CITY OF RIVERSIDE, CALIFORNIA
DEPARTMENT OF PUBLIC WORKS

SEWER PLAN & PROFILE
DIANA AVENUE
R/S - 733
EASTERLY OF EMILY COURT

DATE: 6-2-63 SHEET 1 OF 2

SEWER PLAN & PROFILE
DIANA AVENUE
R/S-733
EASTERLY OF EMILY COURT
HORIZ. SCALE 1"=40'

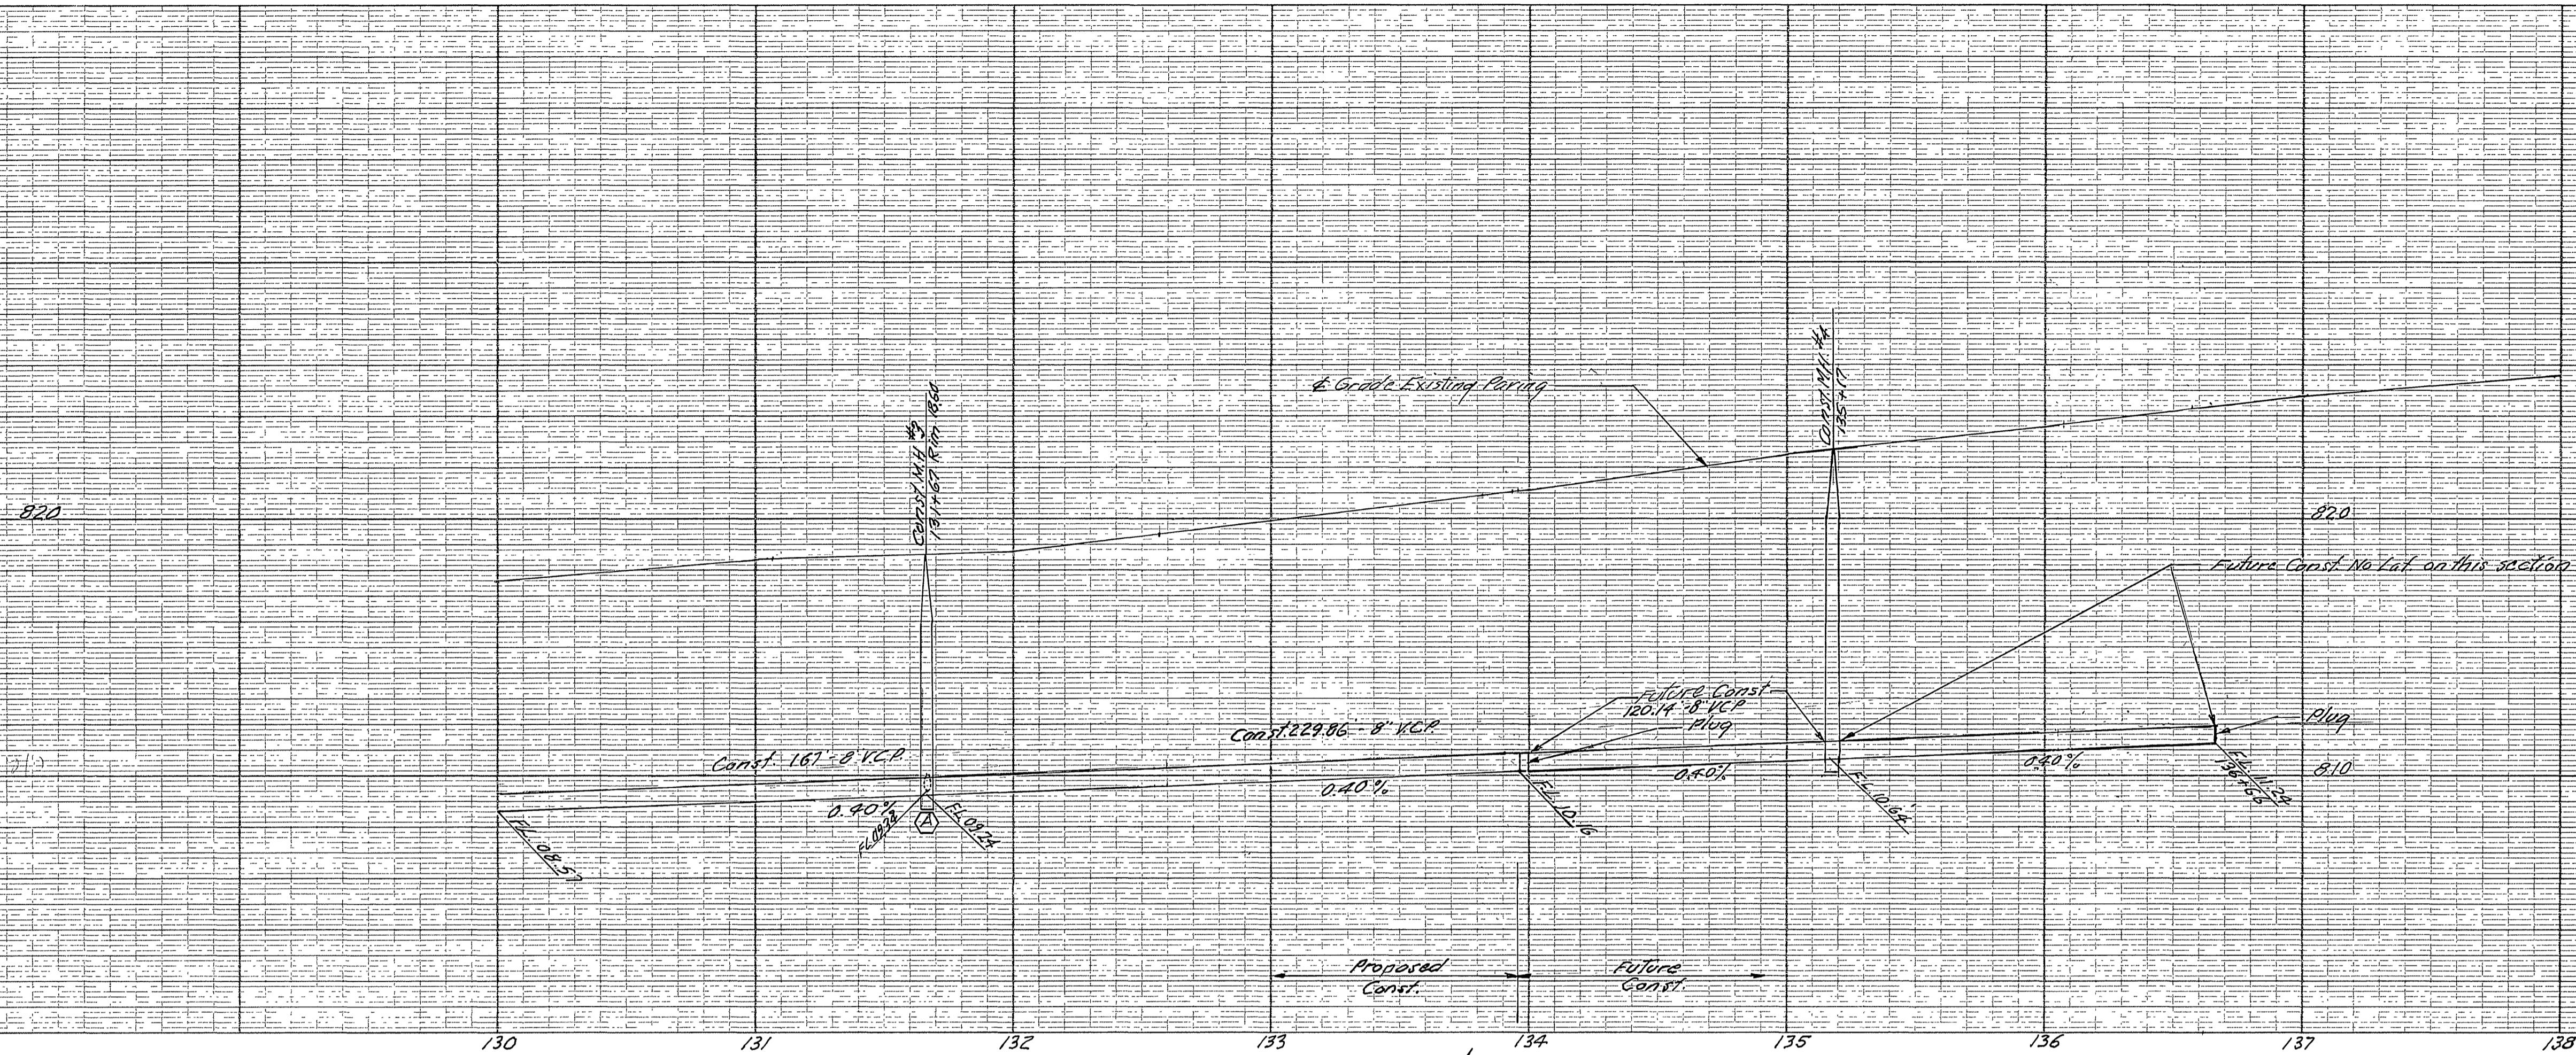
MARK	DATE	DESCRIPTION
(A)	5/20/63	Changed grade to min. 0.40% entire length. added 1/8" to lay all pipes. Add 1'-8" Lat. & Move M.H.# 2-29-64 Elev. 1 C.O. Move M.H.# 2-29-64 Elev. 820.00
